<i>Issue Date</i>	<i>Org. Code</i>	NATIONAL WEATHER SERVICE	<i>Program</i>	<i>Part</i>	<i>Section</i>
	W/OSO321	Engineering Handbook	EHB-11	02	3.6

MODIFICATION INDEX - AUTOMATED SURFACE OBSERVING SYSTEM

ASOS MODIFICATION NOTE 1 (for Electronics Technicians)
Engineering Division
W/OSO321:BGM

PURPOSE : To add maintenance capability and operational
enhancements for the ASOS.

Figure 1

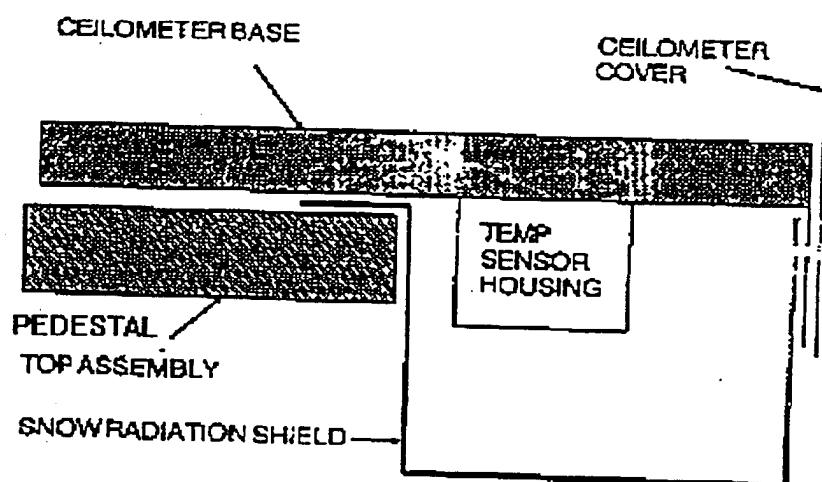
4. The snow radiation shield is held in place by a flange on the edge of the shield. It is installed underneath the ceilometer with one surface parallel to the edge of the ceilometer base and the flange against the pedestal top plate. The flange fits between the top of the pedestal and the bottom of the ceilometer. It is mounted at the opposite end from the fan cable and connector. It is mounted midway between the sides and over top of the ambient air sensor housing which protrudes out of the bottom of the ceilometer. Reference figure 1 for a pictorial view.

10. Insert the shield between the inside edge of the ceilometer and the pedestal top assembly so the flange fits over top of the pedestal. Lower the ceilometer to secure the snow radiation shield. Reference figure 1.

FIGURE 1

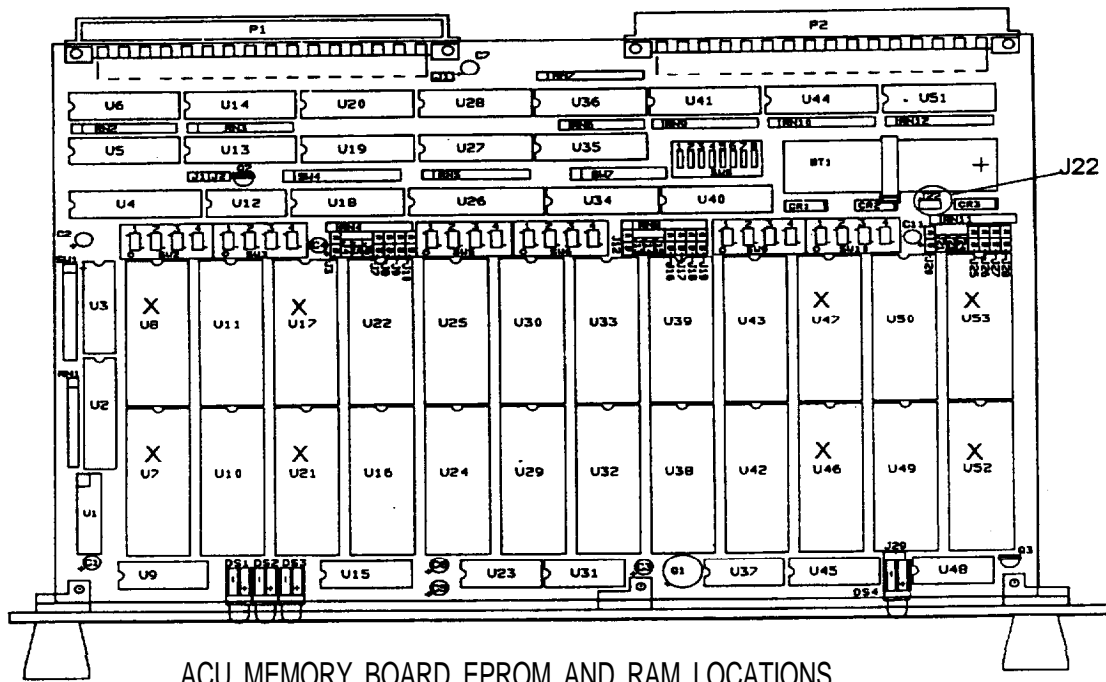
All ASOS application software is contained on the four erasable programmable read only memory (EPROM) integrated circuits (IC) on ACU memory board 1A2A3. Figure 1 illustrates the ACU memory board and identifies the four EPROMs (U8, U17, U7, and U21). The EPROMs are 32-pin dual in-line package (DIP) CMOS devices, each providing 512K x 8 bits of storage. Upgrading ASOS software requires only replacing the four EPROMs on the ACU memory board with higher revision level ICs.

Figure 1 also identifies the four additional RAM chips (U46, U47, U52 and U53). The RAM chips are 32-pin DIP CMOS devices, each providing 128K x 8 bits of storage. There will be no jumpers or switch setting changes to the board. One RAM chip is added to the top of the clock socket/chip (U52). This causes the chip to protrude into the next card slot position.

11. Using the IC insertion tool, remove the new EPROM ICs from protective packaging and insert them into the ACU memory board sockets in accordance with the following chart. Ensure that the EPROMs are installed with pin 1 (as identified by notch in top of IC) oriented toward board connector P1 and P2 as shown on Figure 1.

12. Using the IC insertion tool, remove the RAM ICs from protective packaging and insert them into the ACU memory board sockets U46, U47, U52 and U53. Ensure that the RAMs are installed with pin 1 (as identified by notch in top of IC) oriented toward board connector P1 and P2 as shown on Figure 1. U52 already has a clock chip installed. **DO NOT REMOVE THE CLOCK CHIP.** Install the RAM chip on top of the clock chip.

FIGURE 2

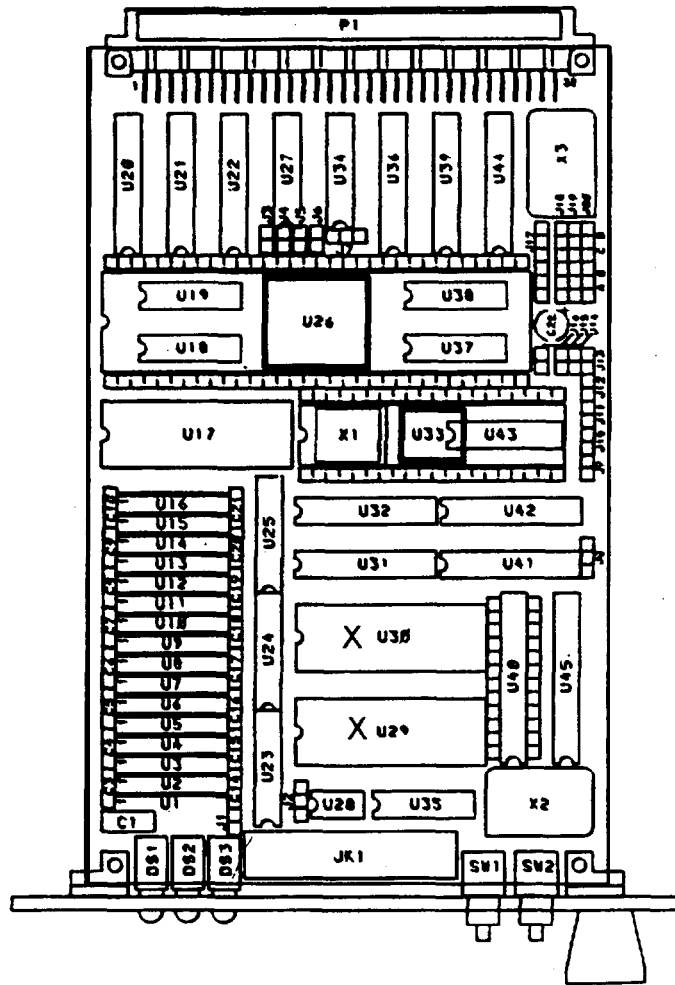
All ASOS operating software is contained on two EPROM ICs on each ACU CPU board 1A2A1 and 1A2A2. Figure 2 illustrates the ACU CPU board and identifies the two EPROMs (U29 and U30). The EPROMs are 28-pin DIP CMOS devices, each providing 256K x 8 bits of storage. Upgrading pSOS ASOS software requires only replacing the two EPROMs on each ACU CPU board with higher revision level ICs.

17. Use a small flat blade screwdriver and tighten the captive screws located at top and bottom of boards and blank panels.
18. If required, remove the new EPROM ICs from the protective packaging. Use an IC insertion tool to insert the EPROMs into the ACU CPU board's sockets (1A2A1 and 1A2A2) in accordance with the following chart. Ensure that all the EPROMs are installed with pin 1 (as identified by notch in top of IC) oriented toward the top of the ACU CPU board as shown on Figure 2.

FIGURE1

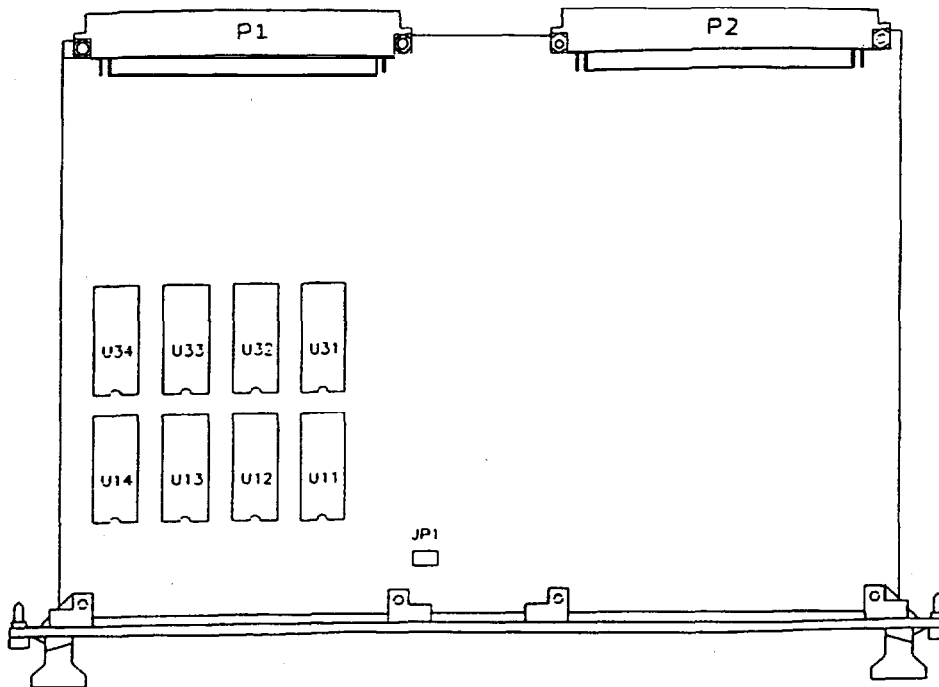
The procedure to upgrade the ACU voice firmware by removing and replacing the eight EPROMs on the Voice Processor board is followed. See Figure 1.

3. Using IC insertion tool, remove new EPROM integrated circuits from protective packaging and insert into Voice Processor board IC sockets in accordance with the following chart. Ensure that EPROMs are installed with pin 1 (as identified by notch in top of IC) oriented toward top of Voice Processor board as shown on Figure 1.

FIGURE 1

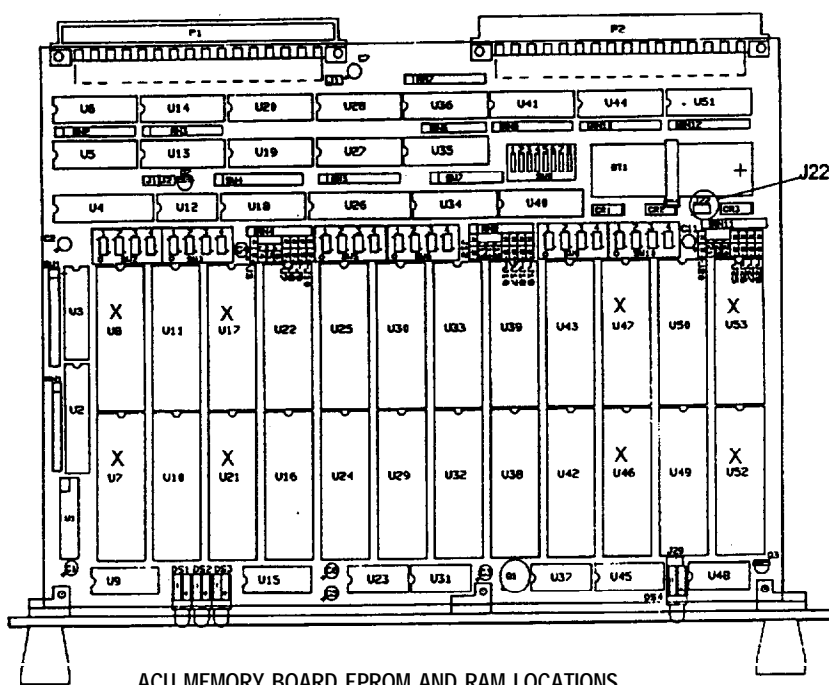
All ASOS application software is contained on the four erasable programmable read only memory (EPROM) integrated circuits (IC) on ACU memory board 1A2A3. Figure 1 illustrates the ACU memory board and identifies the four EPROMs (U8, U17, U7, and U21). The EPROMs are 32-pin dual in-line package (DIP) CMOS devices, each providing 512Kx8 bits of storage. Upgrading ASOS software requires only replacing the four EPROMs on the ACU memory board with higher revision level ICs.

Figure 1 also identifies the four additional RAM chips (U46, U47, U52 and U53). The RAM chips are 32-pin DIP CMOS devices, each providing 128K x 8 bits of storage. There will be no jumpers or switch setting changes to the board. **One RAM chip is added to the top of the clock socket/chip (U52). This causes the chip to protrude into the next card slot position.**

11. Using the IC insertion tool, remove the new EPROM ICs from protective packaging and insert them into the ACU memory board sockets in accordance with the following chart. Ensure that the EPROMs are installed with pin 1 (as identified by notch in top of IC) oriented toward board connector P1 and P2 as shown on Figure 1.

12. Step 12 and 13 can be skipped if ACU memory version 2.23 or later has been installed. Using the IC insertion tool, remove the RAM ICs from protective packaging and insert them into the ACU memory board sockets U46, U47, U52 and U53. Ensure that the RAMs are installed with pin 1 (as identified by notch in top of IC) oriented toward board connector P1 and P2 as shown on Figure 1. U52 already has a clock chip installed. **DO NOT REMOVE THE CLOCK CHIP.** Install the RAM chip on top of the clock chip.

FIGURE 1

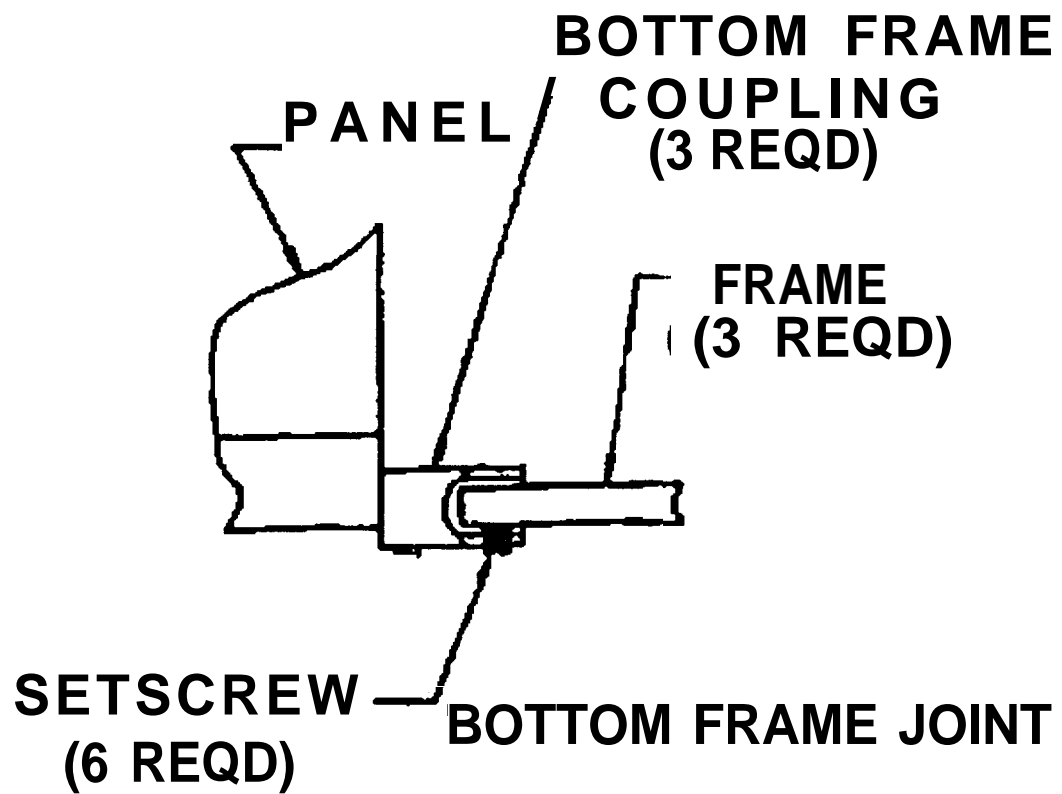
1. At the lower end of the wind skirt assembly remove one of the existing devices.
2. Reference attached drawing figure 1, and replace the removed assembly with a wind skirt attachment device P/N 2125 - 00201.
3. Repeat the process until all three existing attachment devices on the lower ring of the wind skirt are replaced.
4. This completes the Installation of wind skirt attachment devices.
Restore power and return to step 5 on page 3 " AFTER COMPLETING INSTALLATION."

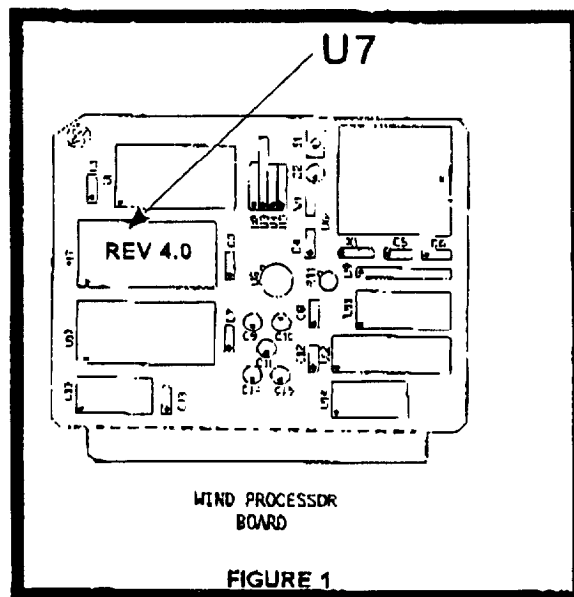
12. Locate U7 (Rev. 3.0 or earlier) on the PCB and remove from the socket using the IC Extraction tool. (Refer to figure 1).

Figure 1 Visibility Sensor Electronics Enclosure

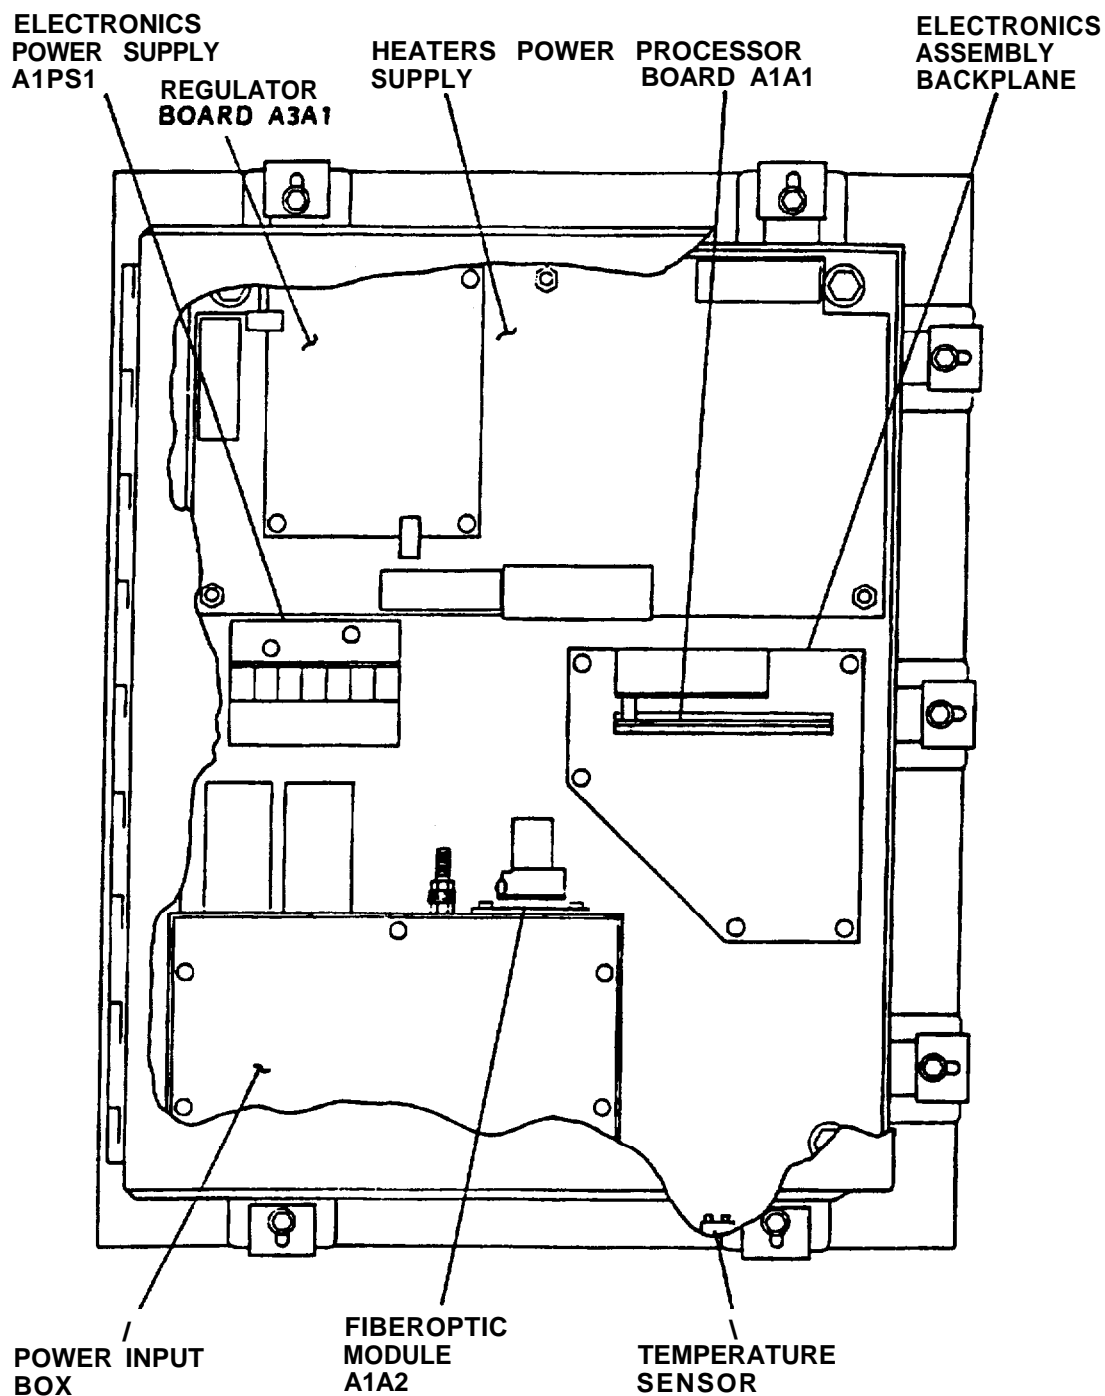
1. At the DCP cabinet, set the visibility sensor circuit breaker module to OFF (right) position.
2. At the sensor, using the large flat-tipped screwdriver, open the visibility sensor electronics enclosure access door and locate the processor board A1A1 (P/N 32194-1). Using the Phillips screwdriver, remove captive screw securing processor board to standoff. This screw is on the bottom side of the board. See figures 1 and 2.

FIGURE 2

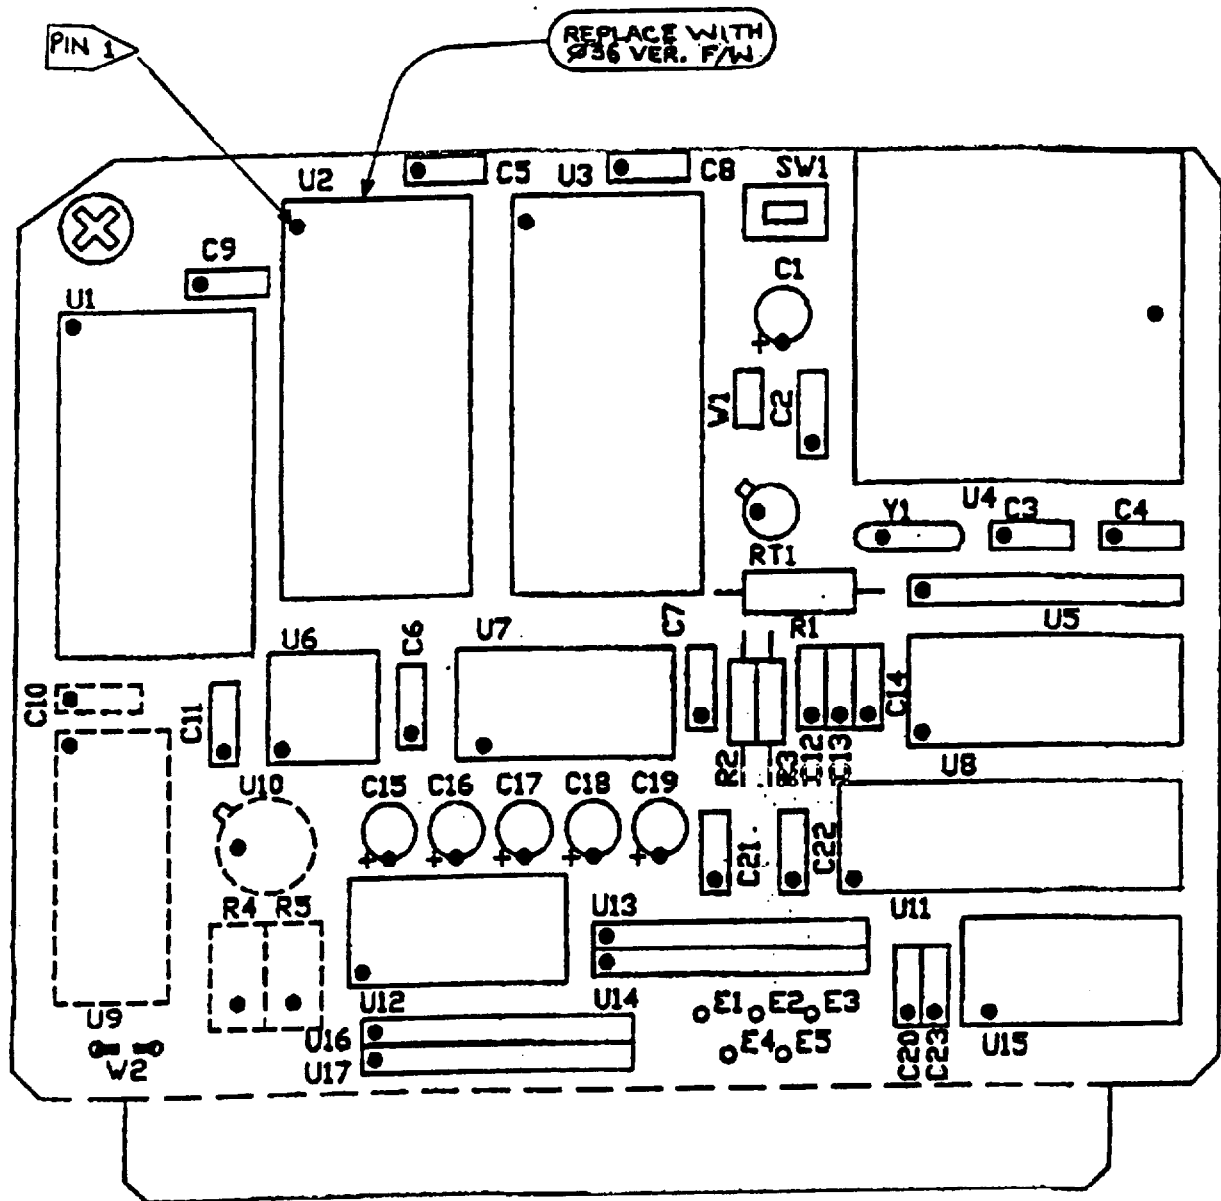
3. Carefully remove processor board by pulling it free from backplane connector XA1.
4. Using Figure 2, locate microcircuit U2. Remove the microcircuit using standard ESD precautions.

Figure 4

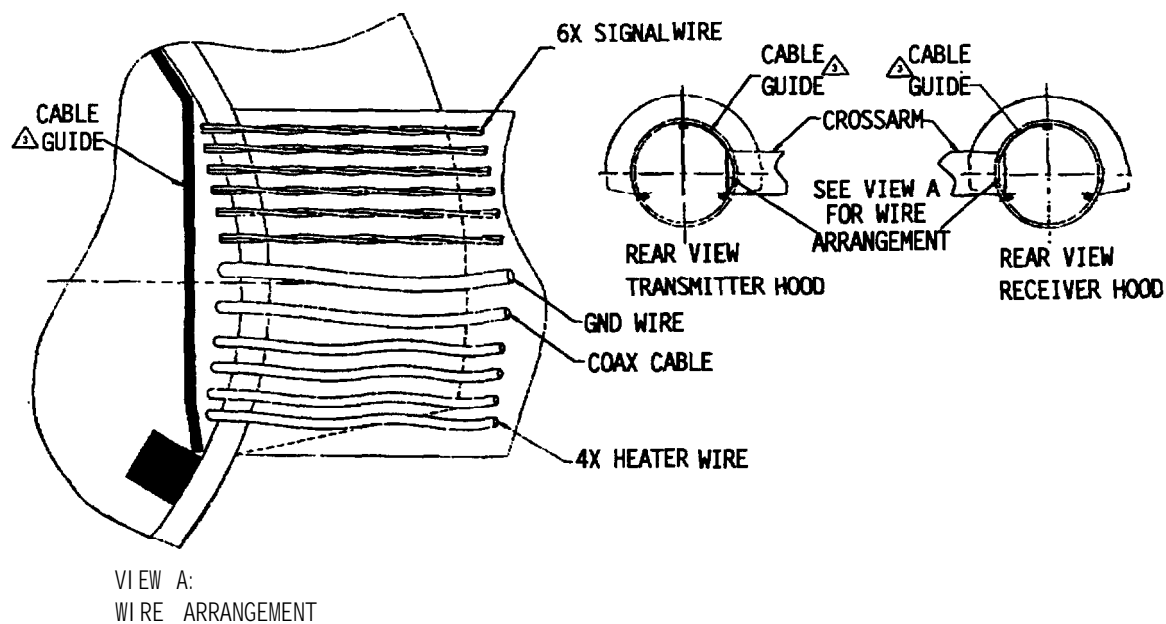
- b. With the tubing removed, the wire bundles can be flattened against the side of the hood. Arrange the wires so the larger heater wires, the green ground wire, and the coax cable are at the bottom as shown in the Figure 4.

FIGURE 1

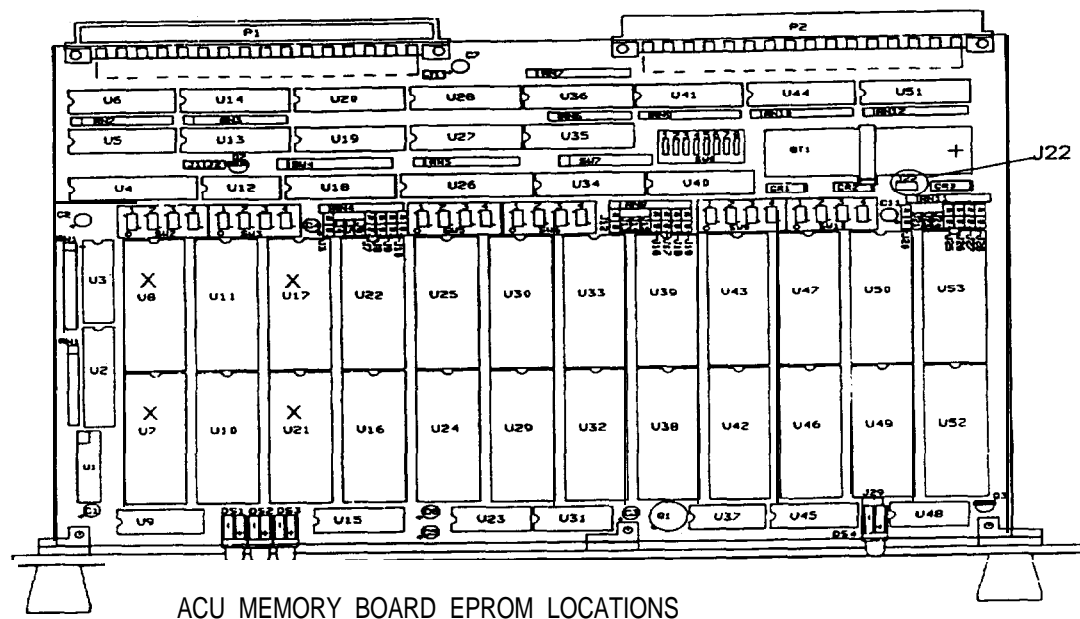
All ASOS application software is contained on the four erasable programmable read only memory (EPROM) integrated circuits (IC) on ACU memory board 1A2A3 or SCA 7A1A1A2A3 memory board. Figure 1 illustrates the ACU memory board and identifies the four EPROMs (U8, U17, U7, and U21) to be replaced. Figure 2 illustrates the DCP memory board 2A1A2A1 and/or 2A1A2A2 and identifies the two EPROMs (U29 and U30) to be replaced. The EPROMs are 32-pin dual in-line package (DIP) CMOS devices, each providing 512K x 8 bits of storage. Upgrading ASOS software requires only replacing the four EPROMs on the ACU memory board with higher revision level ICs.

10. Remove the new EPROM ICs from the protective package and insert them into the memory board sockets in accordance with the following chart. Ensure that the EPROMs are installed with pin 1 (as identified by notch in top of IC) oriented toward board connector P1 and P2 as shown on Figure 1.
